Re: Updated Project Submission
Project Name: 760-790 Center Street Mixed-Use Development
Applicant/Project Sponsor: 1200 Group, LLC c/o Ellicott Development Co. (EDC)

PLANNING BOARD MEETING MINUTES DATED 7/13/2026:

Landscape Plan

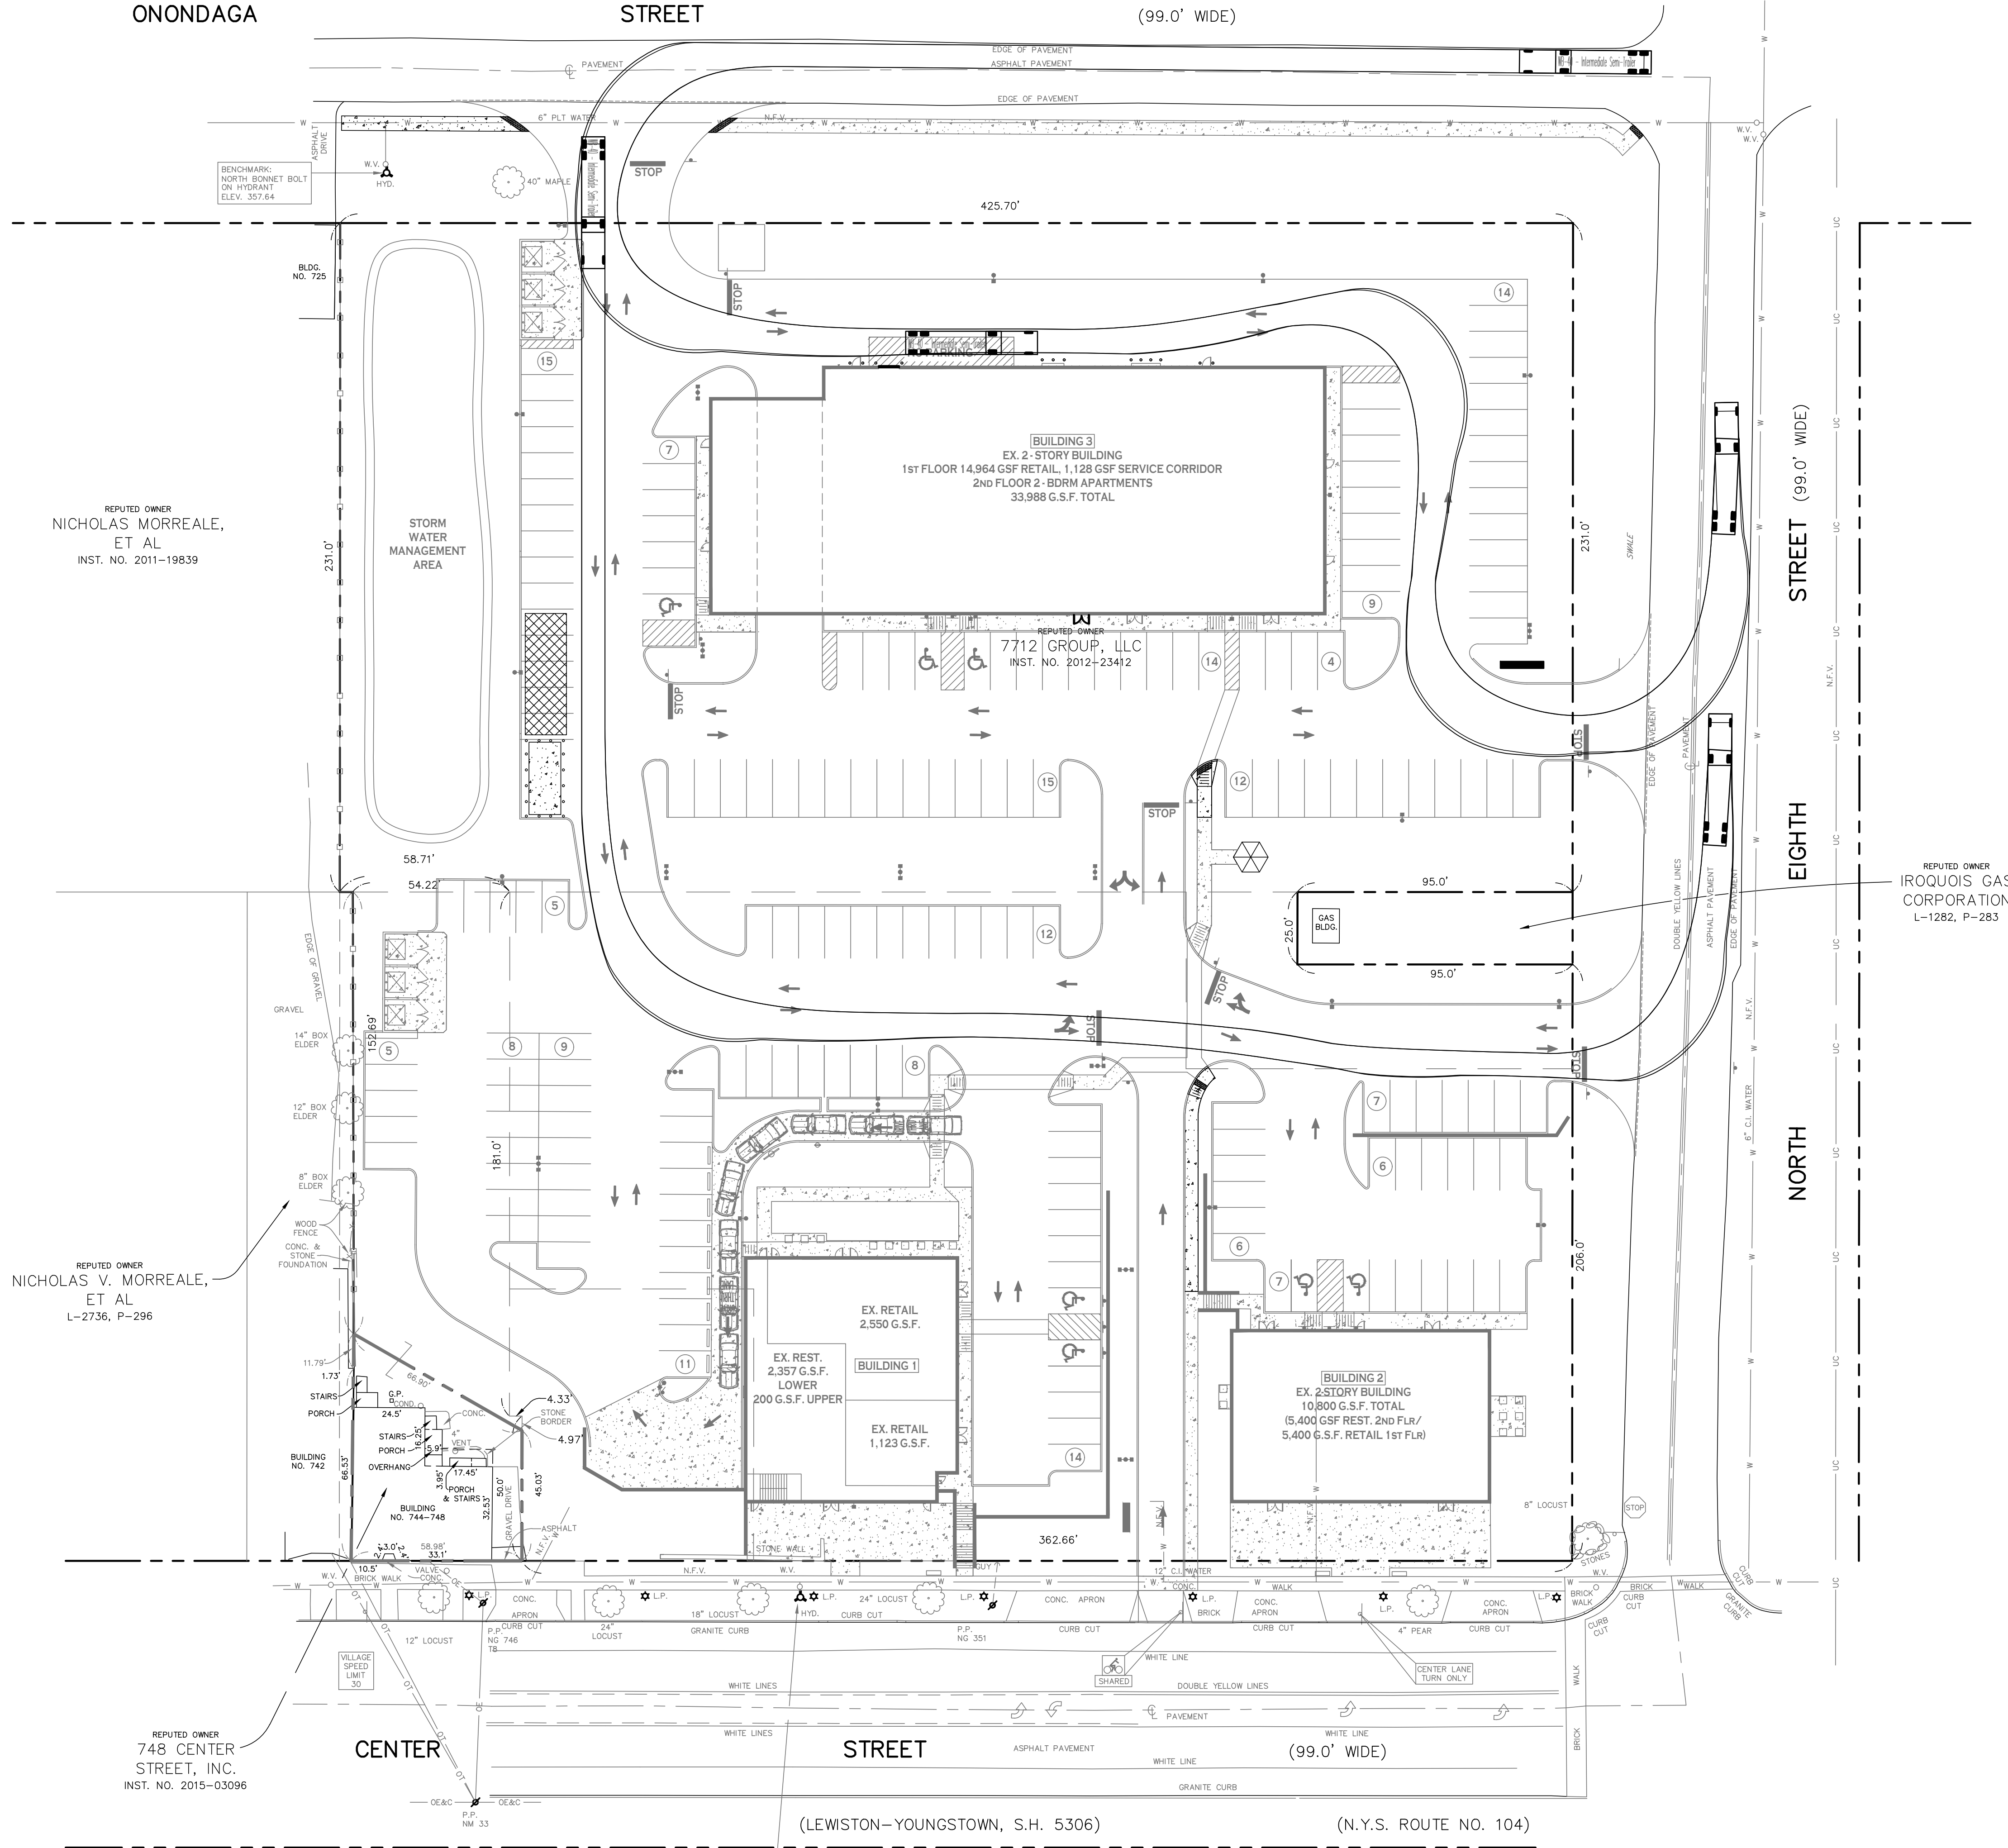
a. Plans show trees and shrubs across the site, many of which have not been planted. This vegetation needs to be installed, or the plan revised to depict the actual planting plan.

b. Previous approvals included additional landscaping along Onondaga Street. This landscaping is not shown on the plans and should be included.

c. The site stormwater features, particularly the detention area at the NW corner of the site, need to be maintained. Some trees on site are either dead or dying. A maintenance schedule should be provided for all landscaping.

Response: After conducting a thorough survey of the Project Site, EDC acknowledges that some landscaping in connection with the 2018 Planning Board approved landscaping plan was never installed. EDC agrees to install this missing landscaping. In addition, EDC proposes to install the additional new landscaping previously proposed to embellish the existing curbed peninsulas at the southeast and southwest corners of Building 3 that was shown on our previously submitted landscaping plan (L-100, dated 5/27/2026, not included herewith). The updated proposed landscaping plan (L-100, dated 9/1/2026, attached as Exhibit "4") reflects the above comments, clouding all the additional landscaping proposed to be installed across the Project Site.

DRAWING NAME:
Truck Turning
Plan - Fire Truck

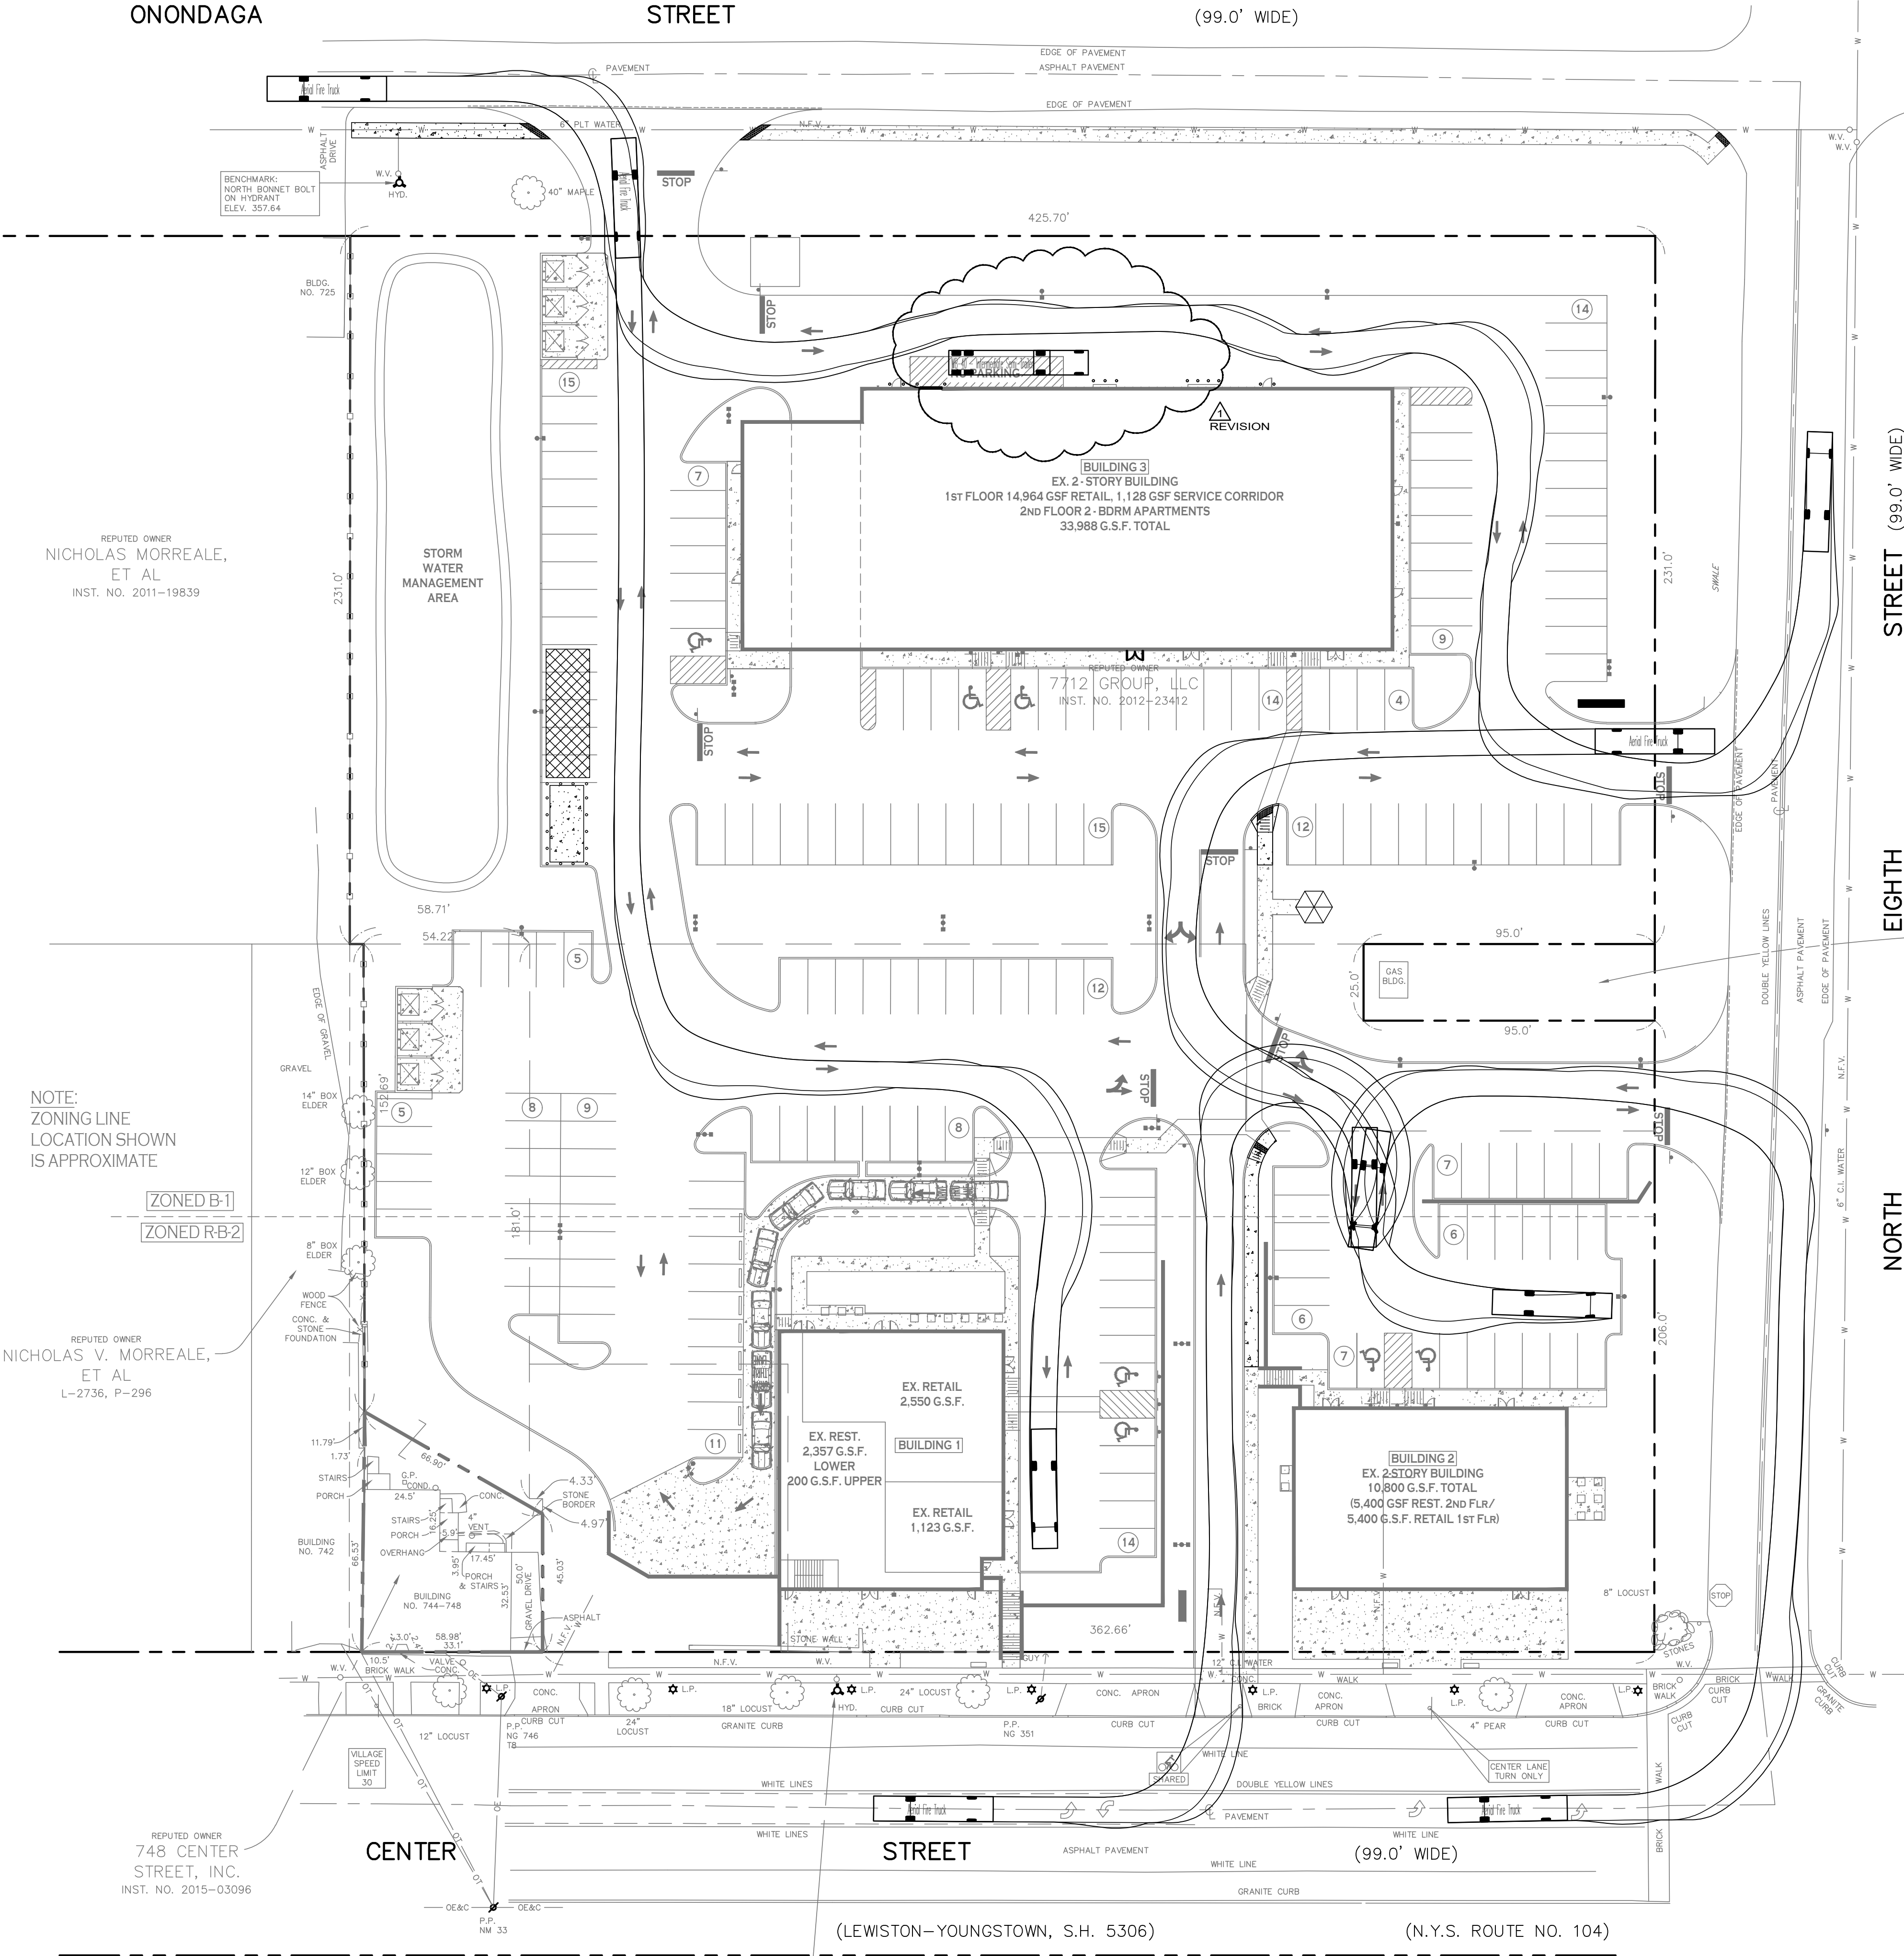
e. The Loading Zone is 10’ wide, but effectively closer to 8’ since it abuts the building. This could reduce the effective width of access between the loading area and the north edge of pavement to less than 20’. Is the Fire Marshall ok with this?

Response: A Fire Truck Turning Map (T-100, dated 9/1/2026, attached as Exhibit “5”) illustrates that there is enough room for a fire truck to access the north side of Building 3 if during the same time in which a tractor-trailer is located in the dedicated loading zone.

12 Ft. Meridian Octagon Gazebo

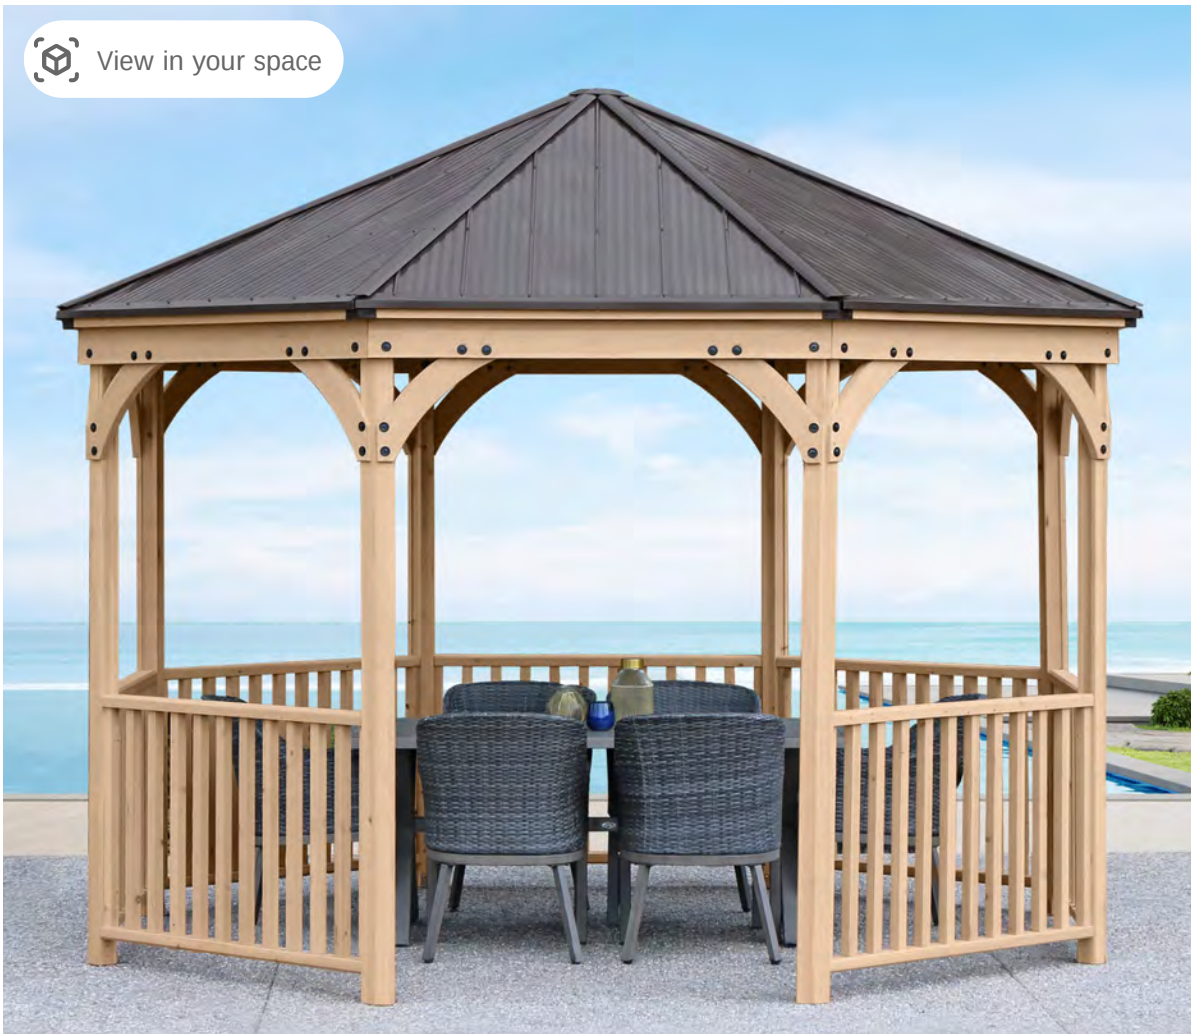
g. Details and dimensions should be provided for the proposed Gazebo. It also needs to be shown on the grading plan as the location is shown near a storm structure and in the area where the grade drops off significantly to the National Fuel building.

Response: The proposed gazebo is shown on the previously submitted grading plan, Drawing C-200 (not included herewith). A detailed specification for the proposed gazebo is attached here as Exhibit “8”.
